Addendum #3

***City of Pearl Parks and Recreation Phase 2:
City Park Improvements
Pearl, MS***

June 15, 2020

E0.0

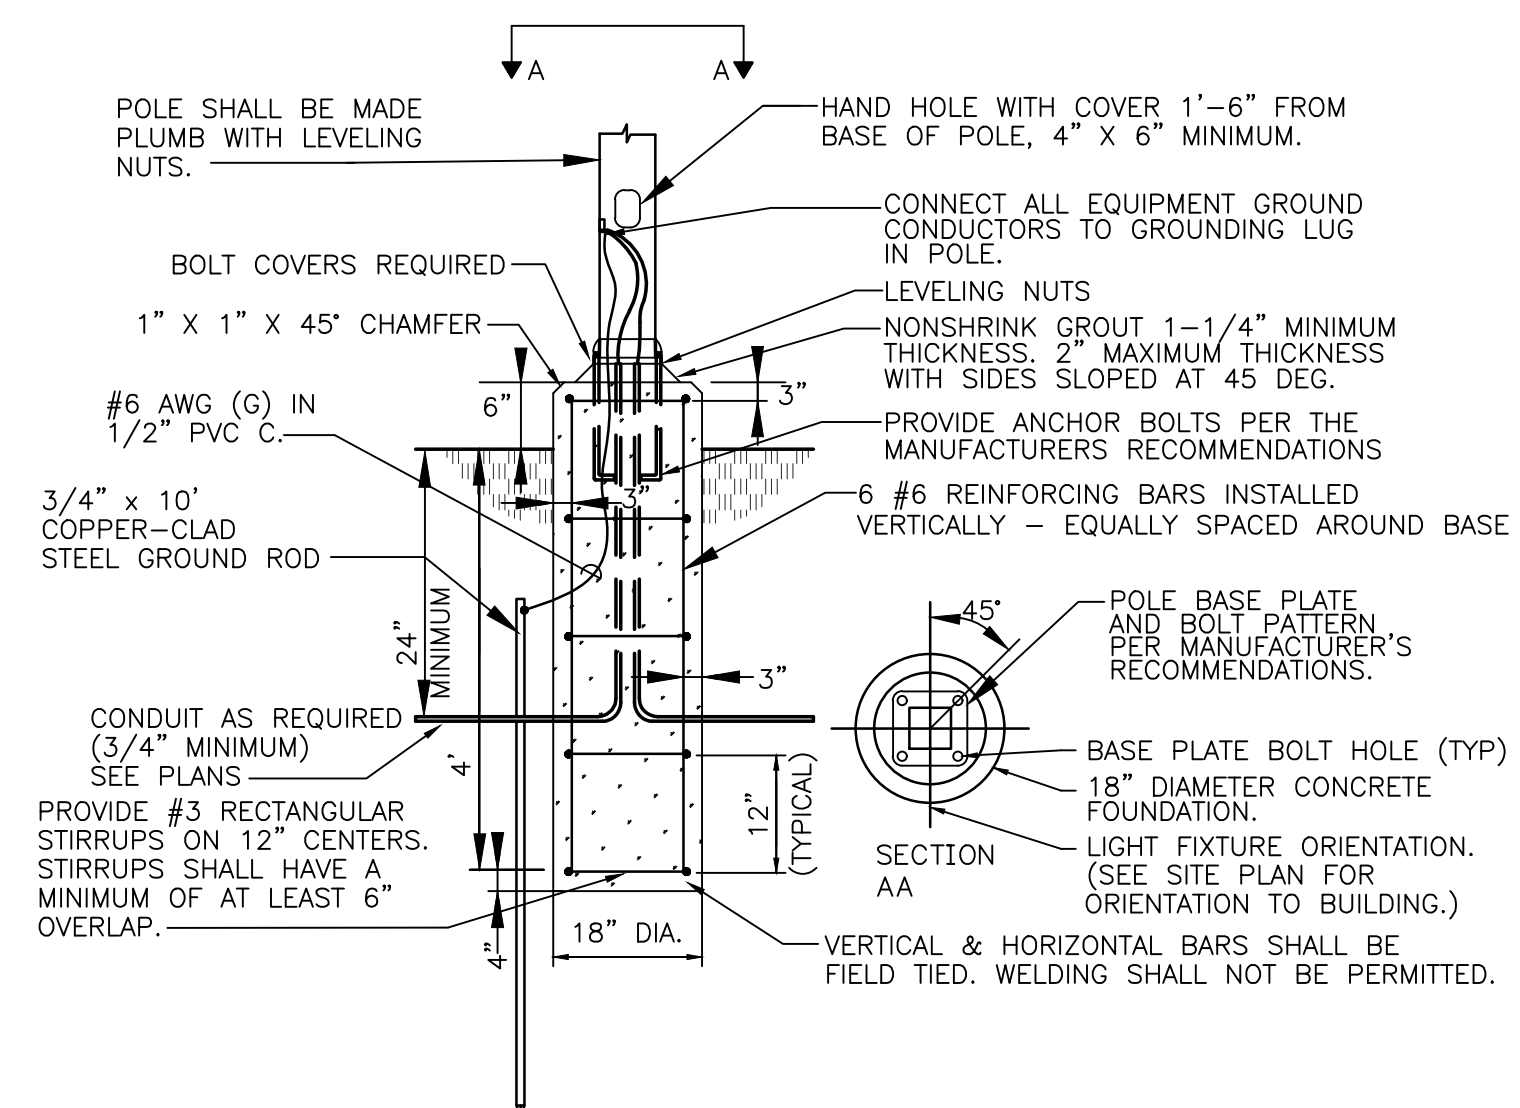
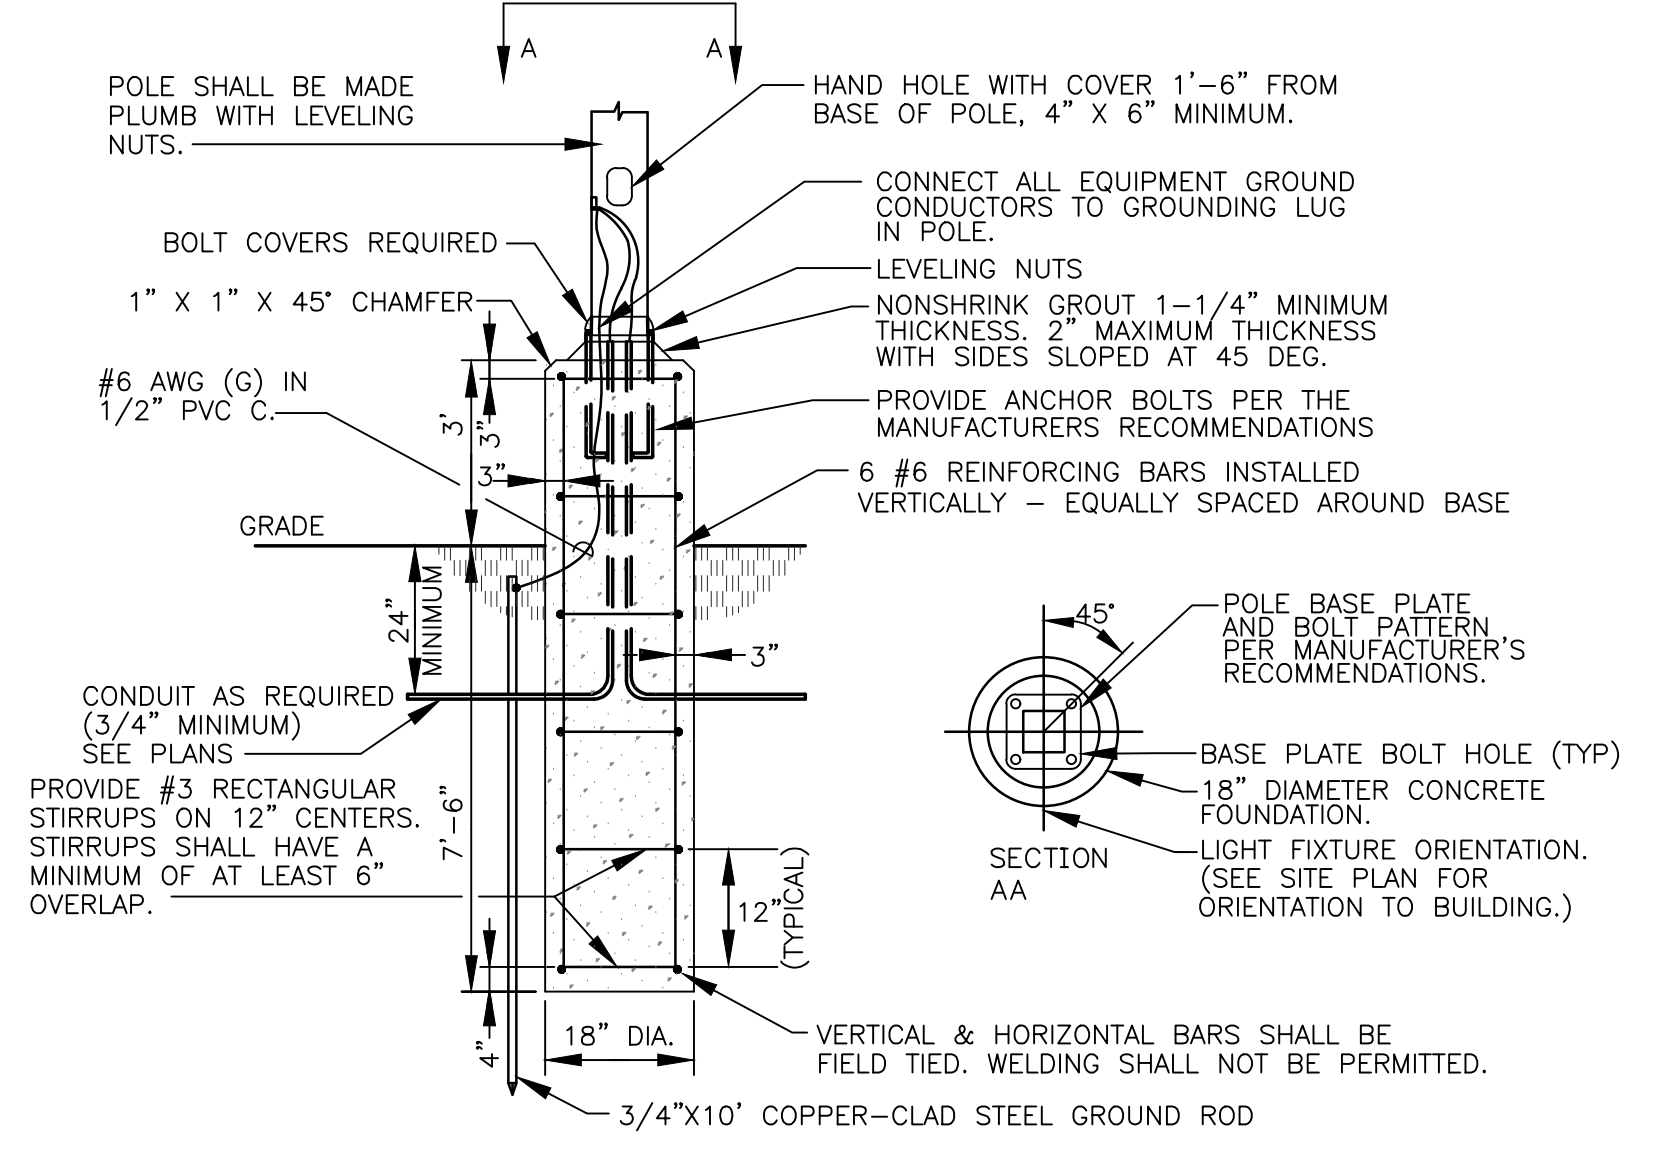
1. Replace the original drawing sheets with the following revised sheets clouded and noted with Revision 3-Addendum dated 6-15-20: **E0.0 and E0.3.**
